**BOARD ACTION REPORT – APPEALABLE ITEM**

**Project Name:** 105 NE 1<sup>st</sup> Street  
**Project Location:** 105 NE 1<sup>st</sup> Street, Old School Square Historic District  
**Request:** Architectural Elevations and Certificate of Appropriateness  
**Board:** Historic Preservation Board  
**Meeting Date:** June 6, 2018

## STAFF REPORT

**ITEM:** 105 NE 1<sup>st</sup> Street, Old School Square Historic Arts District – Architectural Elevations and Certificate of Appropriateness (COA) 2018-055 for alterations to the elevations for Phase II of the approved project formerly known as Hyatt Place associated with the construction of a new 26,166 sq. ft. two-story office building.

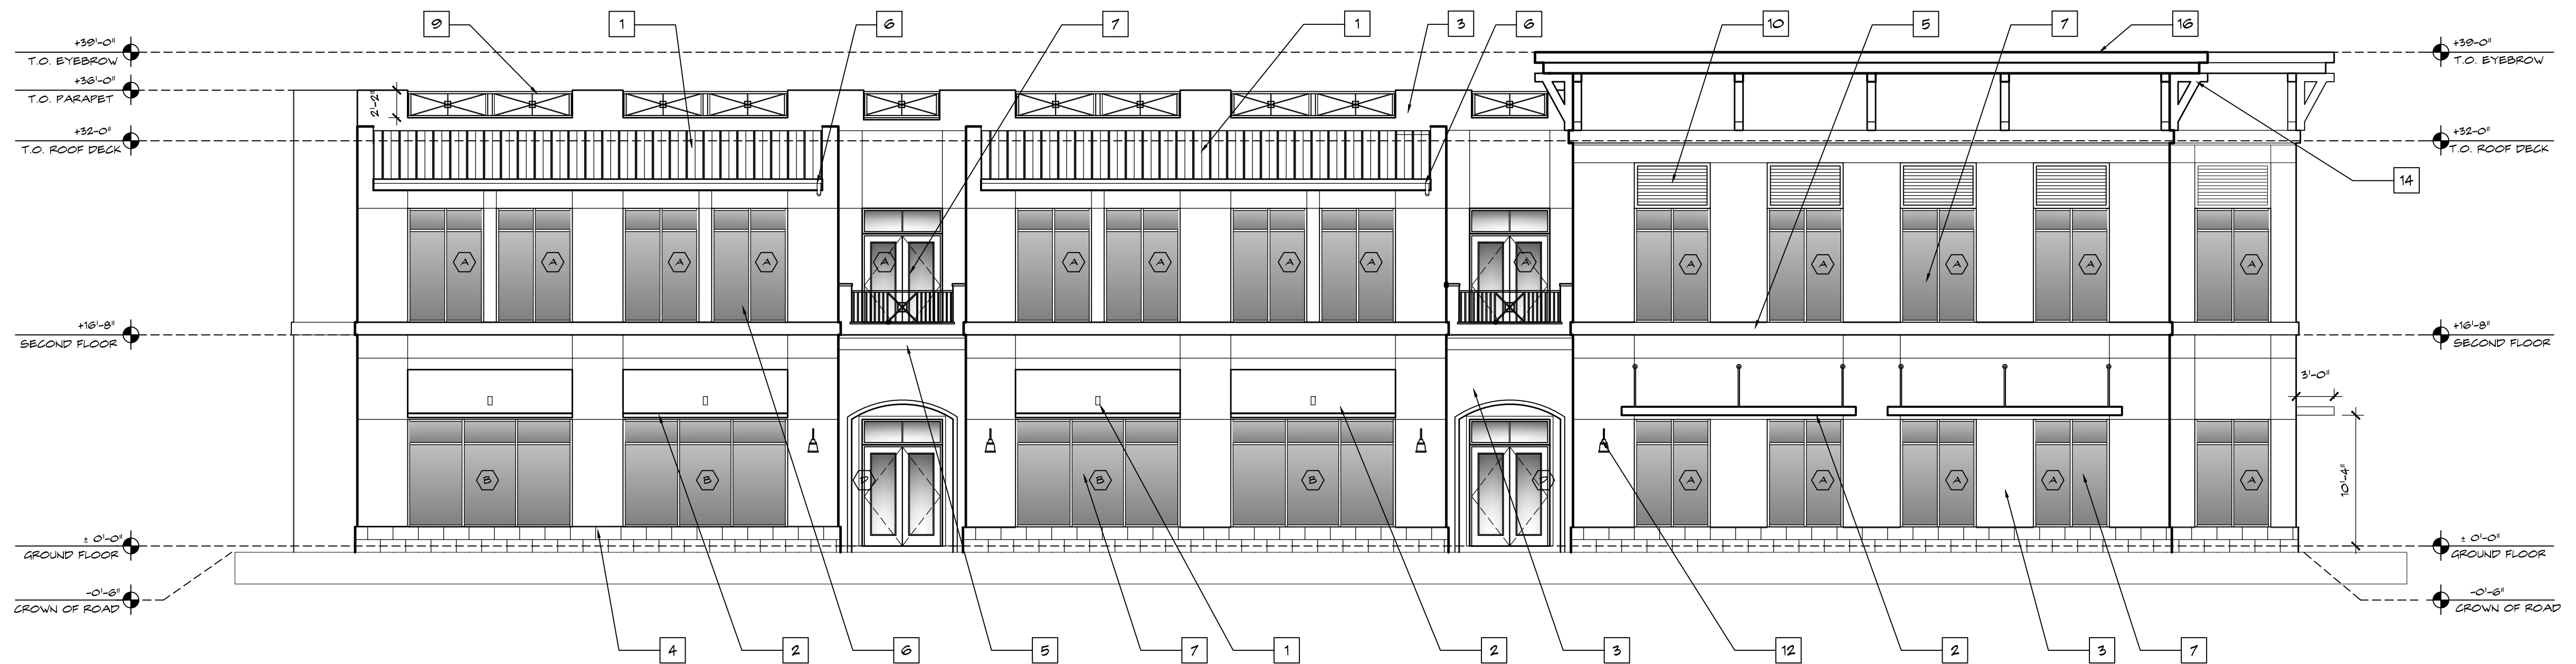
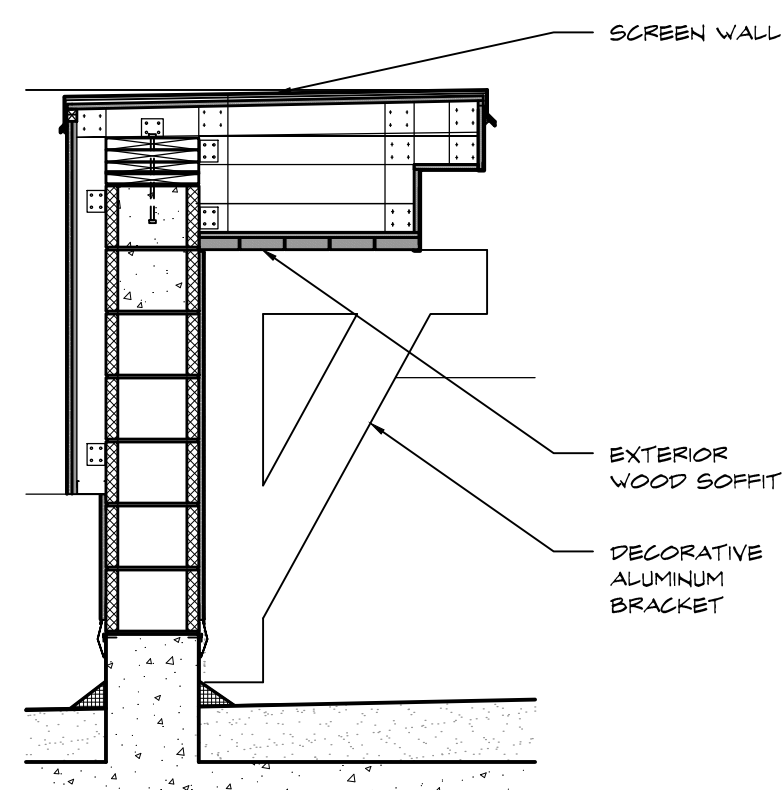
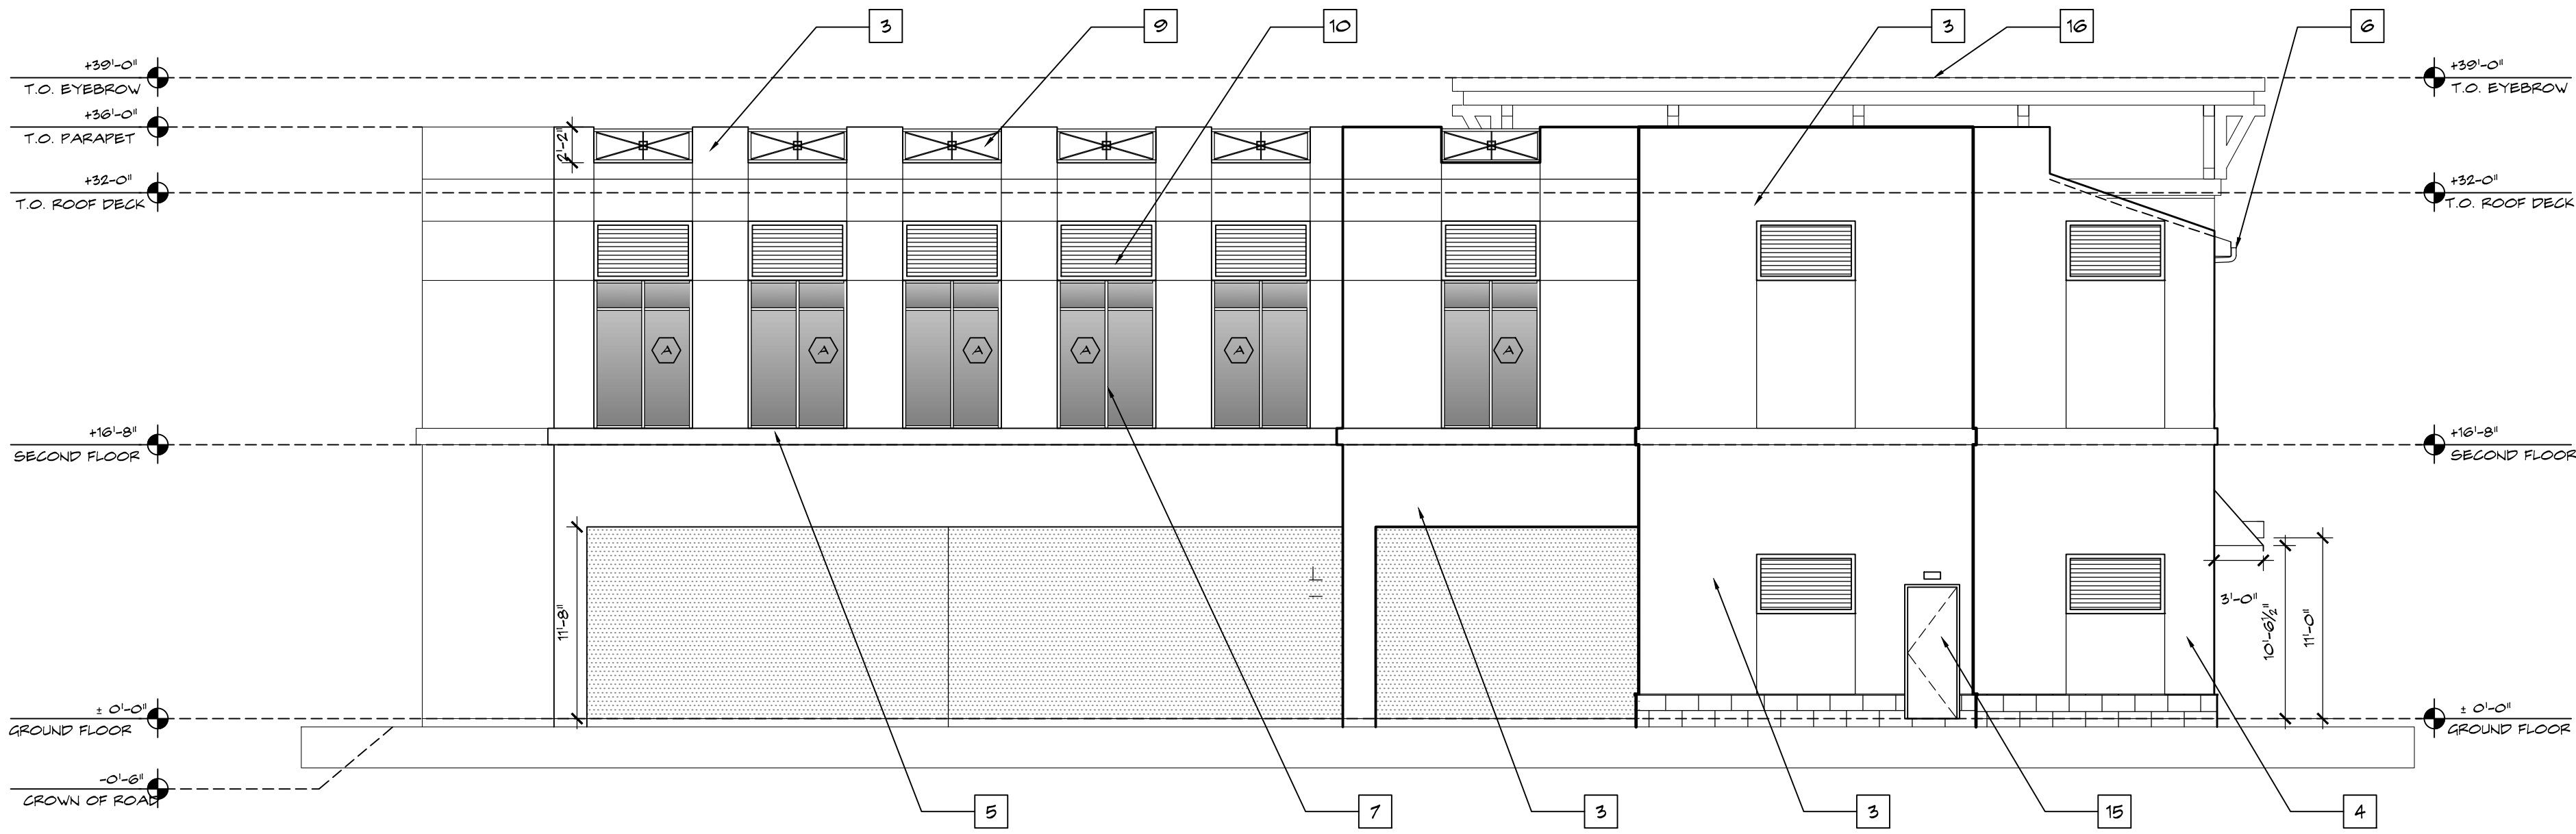
- 1. That building width dimensions be provided on sheet A3.0.1 and A3.0.2
- 2. That a note be added to indicate the color of the decorative aluminum brackets and the type of material that will be used for the wood soffit on sheet A3.0.1 and A3.0.2.
- 3. That a note be added to indicate the material and color of the balcony railings on sheet A3.0.1.
- 4. That a window and door schedule which provides window and door type, material, configuration, dimensions, and profile drawings be included on a separate plan sheet.

2 NORTH ELEVATION  
SCALE: 1/8"=1'-0"

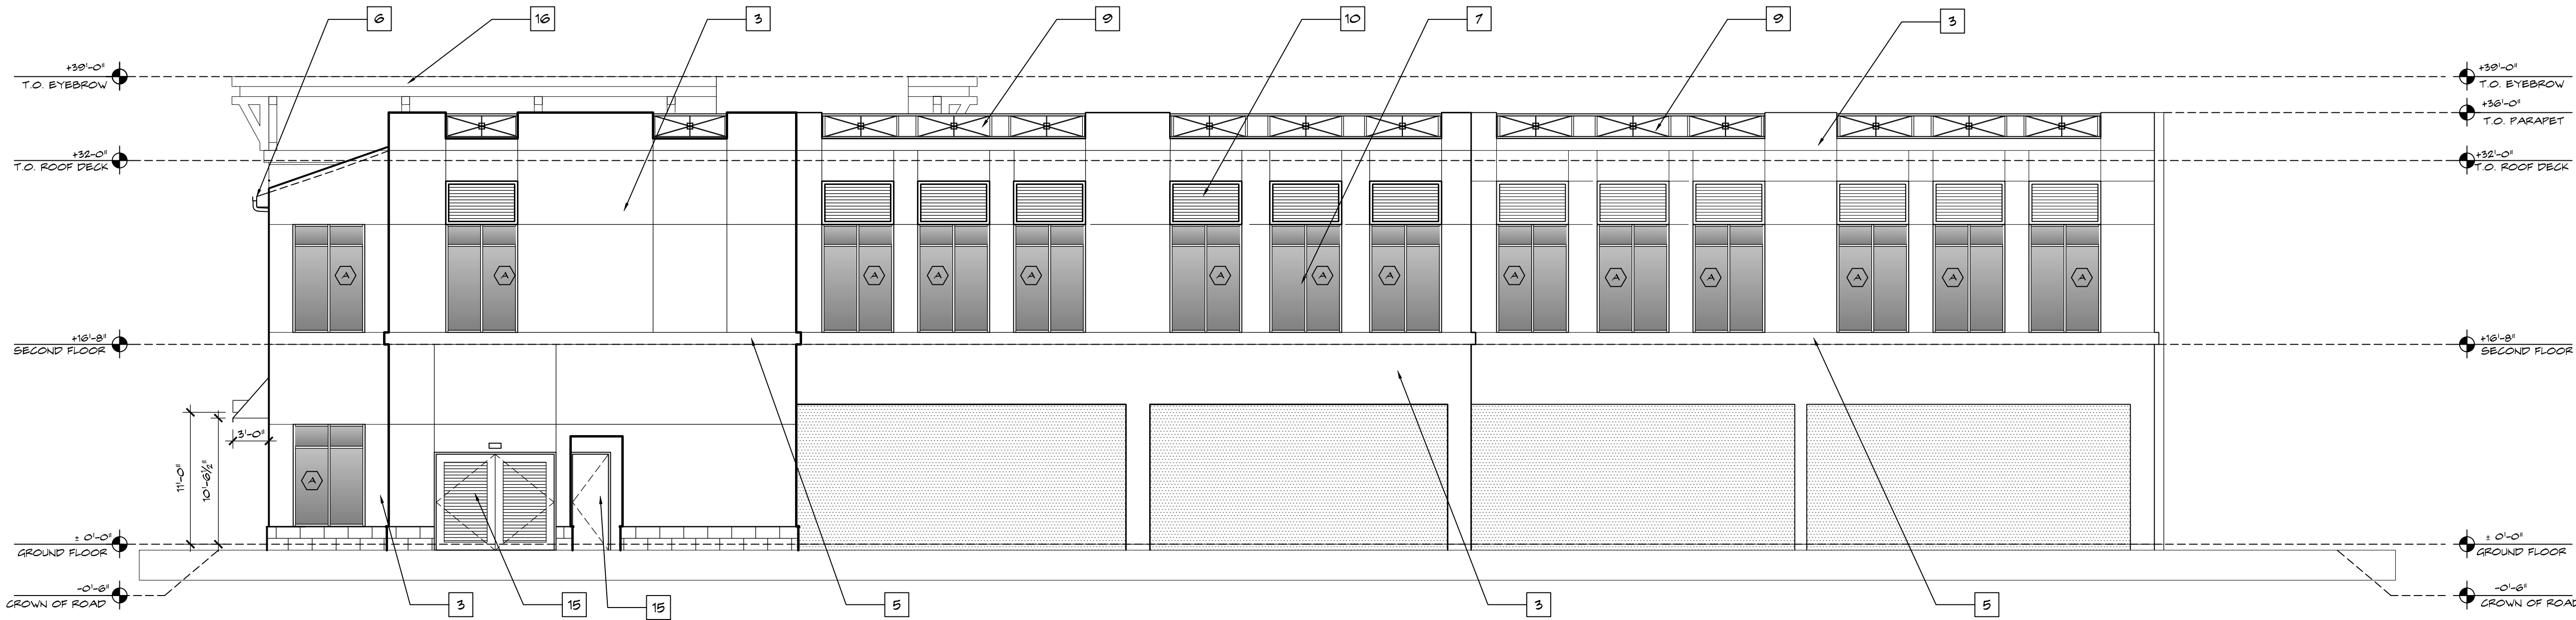
One member of the public (neighboring property owner) discussed privacy concerns regarding the second-floor window openings on North side of the structure.
